Rationale for modifications to state diagram in Figure 93-28

Marek Hajduczenia, Nokia Siemens Networks S.A.

Current (D1.3) of Fig. 93-28

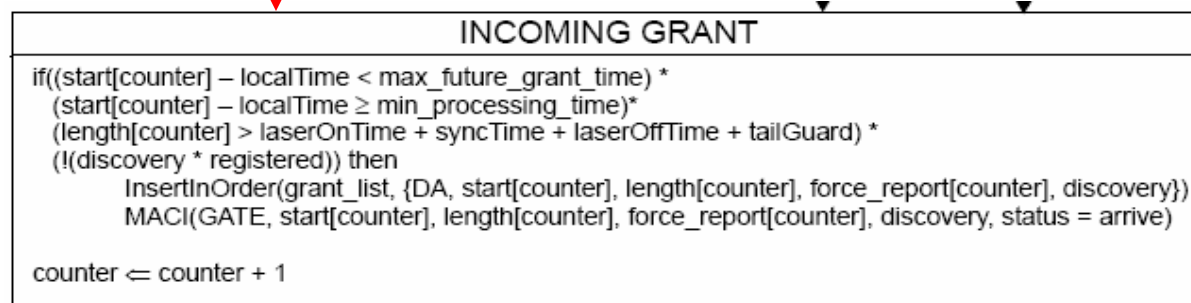
- Parse incoming GATE MPCPDU
- decide whether the carried grants should be accepted and inserted into grant list or not

- if the size / start time of the grant is OK and the grant was received when
 - ONU is unregistered and discovery grant was received
 - ONU is registered and regular grant was received

- an issue was identified with the **if** statement. Observe the Karnaugh map under the assumption that the slot size and start time is OK i.e. **(start[counter] – localTime < max_future_grant_time) * (start[counter] – localTime ≥ min_processing_time) * (length[counter] > laserOnTime + syncTime + laserOffTime + tailGuard)** is true

- ONU is not registered and still could accept a GATE
- probably not dangerous (no LLID in RS anyway)
- if possible, plug this hole when correcting Fig. 93-28 state diagram

- issue identified in PARSE GATE state:
- imagine an ONU with 1G upstream
 - OLT schedules 10G discovery window
 - ONU cannot register in this window:
 - confirmDiscovery returns FALSE
 - discovery ← FALSE
 - registered ← FALSE
 - INCOMING GRANT state accept such a grant (see previous slide)
 - solution needed to avoid such situation

Proposed changes to Fig. 93-28

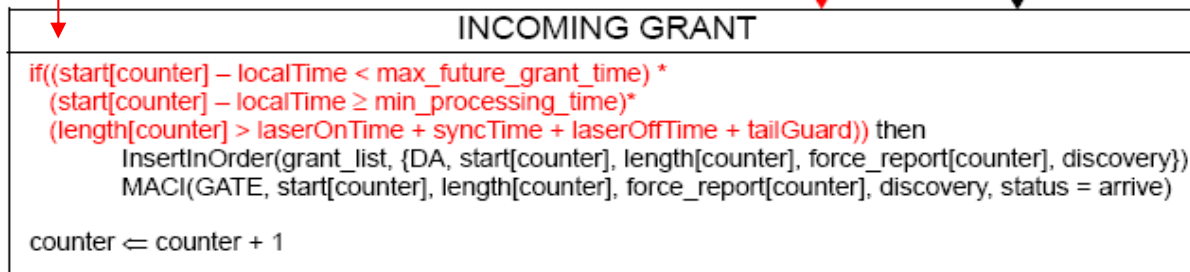
Changes proposed to PARSE GATE state:

- a new Boolean flag **gate_accepted** to indicate whether the GATE grant(s) are to be accepted or dropped
- conditions:
 - if the ONU is not registered and the incoming GATE is a Discovery GATE and confirmDiscovery evaluates to TRUE > set gate_accepted to TRUE and fetch syncTime
 - if the ONU is registered and the incoming GATE is a regular granting GATE > set gate_accepted to TRUE
 - otherwise gate_accepted is kept with FALSE value
- based on gate_accepted, either WAIT or INCOMING GRANT state is called

- the conditional statement is simplified, since the incorrect GATEs are filtered at the end of the PARSE GATE state;
- the if statement can be changed to **if ((start[counter] – localTime < max_future_grant_time) * (start[counter] – localTime ≥ min_processing_time) * (length[counter] > laserOnTime + syncTime + laserOffTime + tailGuard))**
 - only slot size and slot start time needs to be checked
 - insertion into the grant list is performed exactly like in D1.3
 - exit conditions from INCOMING GRANT state are exactly like in D1.3
